Subject: Barnageeragh Landfill - Regulation 7 Notice H0167-01
Attachments: MGE0755LT0002 Response to EPA Queries F01.pdf

Our ref: MGE0755LT0002

RE: H0167-01 - Barnageeragh Landfill – Notice in accordance with Regulation 7(4) of the Waste Management (Certification of Historic Unlicensed Waste Disposal and Recovery Activity) Regulations, 2008

Project	BARNAGEERAGH HISTORIC LANDFILL TIER 2 AND TIER 3
Title	BARNAGEERAGH HISTORICAL LANDFILL SITE LOCATION MAP
File Identifier	MGE0755-RPS-00-XX-DR-C-DG0001-01
Status	S0
Rev	F01

1.8 Timescale for Remediation

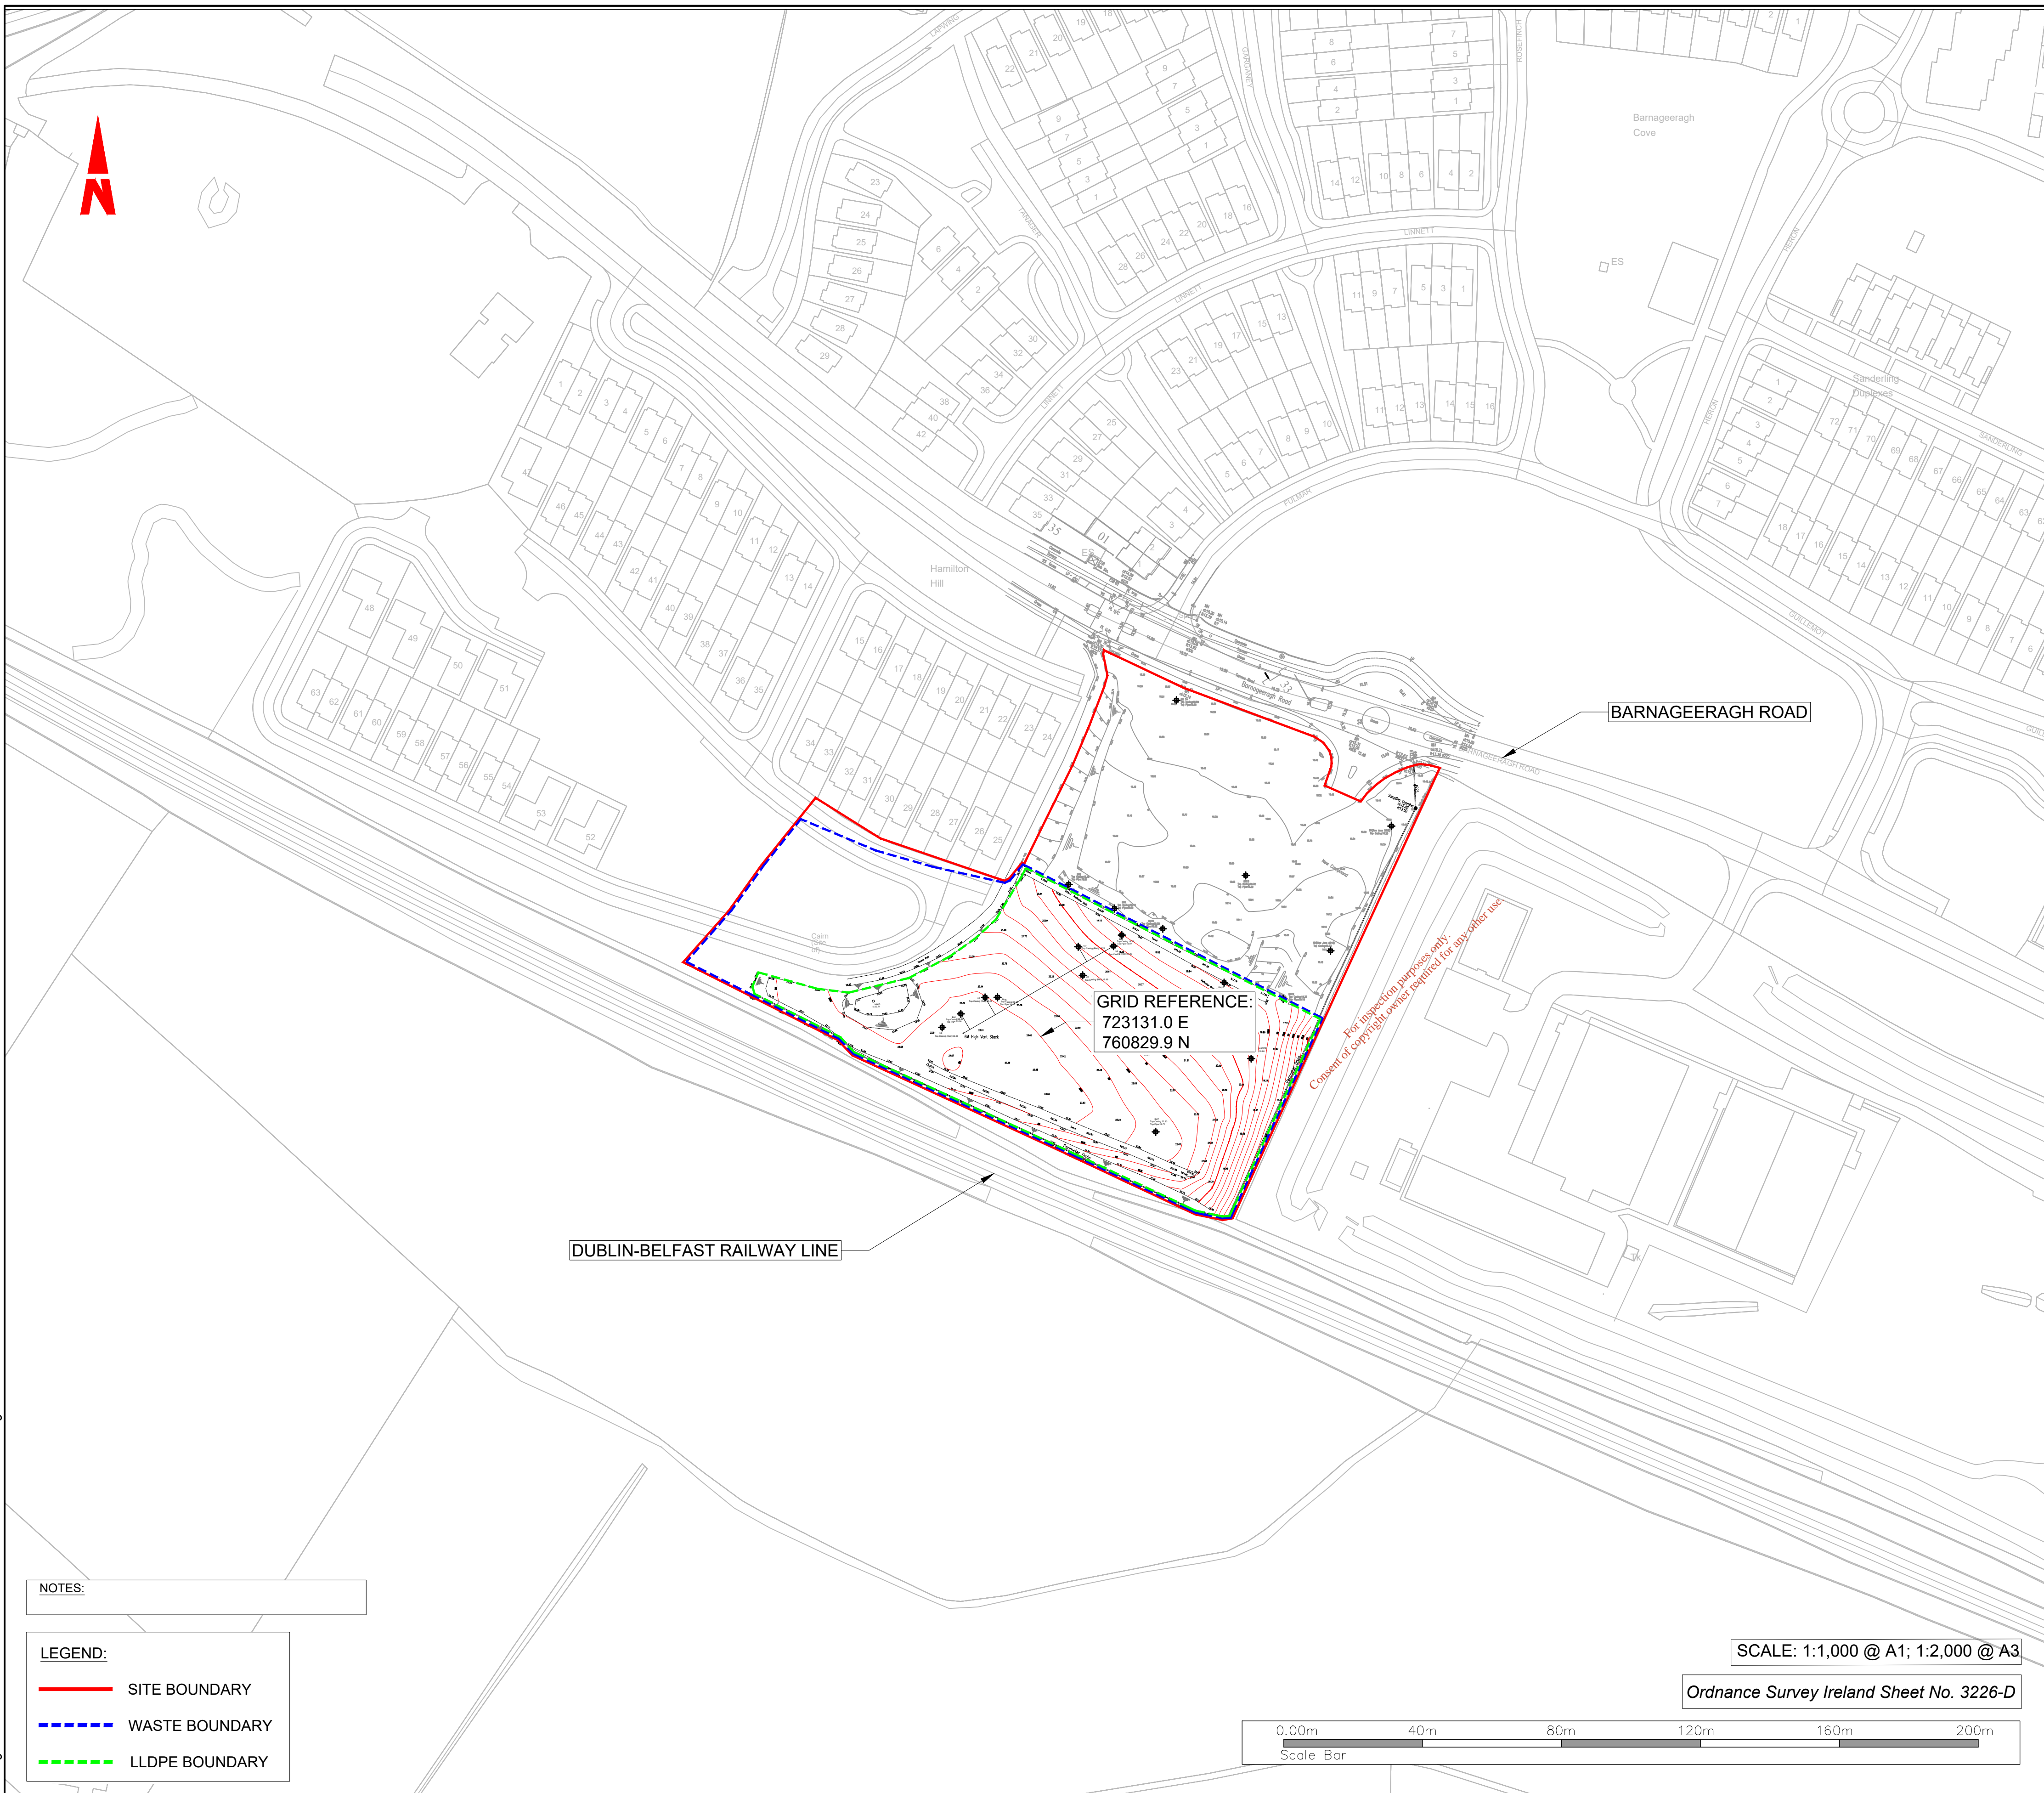
The attached updated drawing MGE0755-RPS-00-XX-DR-C-DG0001-01 is the correct drawing alongside drawing and MGE0755-RPS-00-XX-DR-C-DG0001-02. These drawings have been updated to incorporate a site survey completed by the developer in October 2020. The drawings show the site boundary, interpreted waste boundary and the line of the LL/DPE capping. Section 1.2 of the non-technical summary has been updated to reflect this.

(d) The site boundary on the drawings have been updated to include TP43.
